Technical Service Information

FORD 4EAT PROBE REVERSE CLUTCH FAILURE

Figure 1

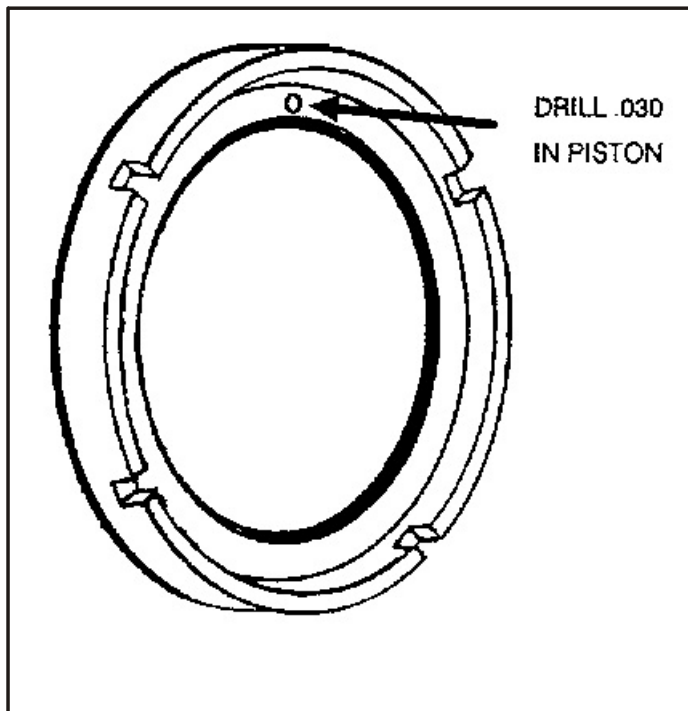
- COMPLAINT:** Repeated reverse clutch failure.
- CAUSE:** Cross leak causing the reverse clutch to drag while in forward gears.
- CORRECTION:** Drill a .030 hole through the reverse piston (figure 1), also enlarge the reverse feed orifice by .020 (figure 2). Example: measure existing orifice size, if it is .059 then enlarge to .079.
- NOTE:** Always use factory rings from Ford. These rings will work on both Mazda and Probe. (part # E92Z-7D019-A).
